UNITED STATES PATENT AND TRADEMARK OFFICE

APPLICATION NO.	FILING DATE	FIRST NAMED INVENTOR	ATTORNEY DOCKET NO.	CONFIRMATION NO.
09/688,989	10/17/2000	Yoshitaka TSUNASHIMA	04329.1952-01000	2408

Office Action Summary	Application No. 09/688,989	Applicant(s) TSUNASHIMA ET AL.	
	Examiner Steven H. Rao	Art Unit 2814

Response to Amendment

FIG. 3E (PRIOR ART)

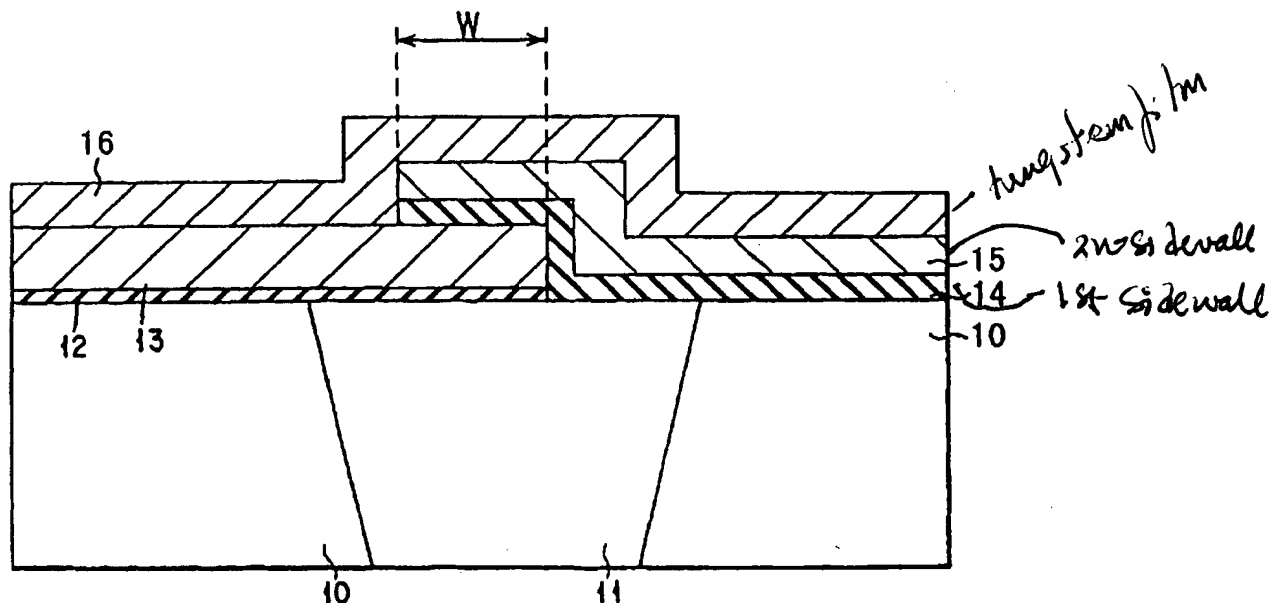
Applicants' contention with regard to AAPR (Applicants' Admitted Prior Art) that , "Fig. 3E of Applicants' specification shows a second gate electrode 15 is connected to a tungsten silicide film 16. However, a side wall located at the end of the second gate electrode 15 is not connected to a side wall at the end of the tungsten silicide film 16. Instead, the side wall at the end of the second gate electrode 15 is connected to a mid-portion of the tungsten silicide film 16 . Therefore, Fig. 3E fails to teach the claimed "first side wall is located at an end of the first gate electrode in the first direction, a second side wall is located at an end of the second gate electrode in the first direction, and the

In Fig. 3E , Applicants' are correct in identifying elements 14 and 15 as the first and second gates .

However Applicants' must (as per their presently recited claims) must identify the first side wall is located at an end of the first gate electrode in the first direction as the side wall of 14 (at the right extreme of 14 when looking at it).

Similarly Applicants' must (as per their presently recited claims) must identify identify a second side wall is located at an end of the second gate electrode in the first

direction as the sidewall of 15 above sidewall of 14 (at the right extreme of 15 when looking at it) and further to meet the recitation located at an end of the second gate electrode and in the first direction (emphasis supplied) which is (and the first side wall) directly physically and without the presence of additional layers there between connected to the second side wall above the isolation element. (all of which are above isolation element 12e.g. fig. 3E).

Applicants' equating the other end of gate electrode 15 and the corresponding sidewall at that end as the one is not commensurate with the presently recited claims and further based on this assumption concluding this side wall of 15 (at the other end) is connected to the mid-portion of the tungsten silicide film 16 (which is further processed to form third electrode) cannot form the basis of an convincing argument .
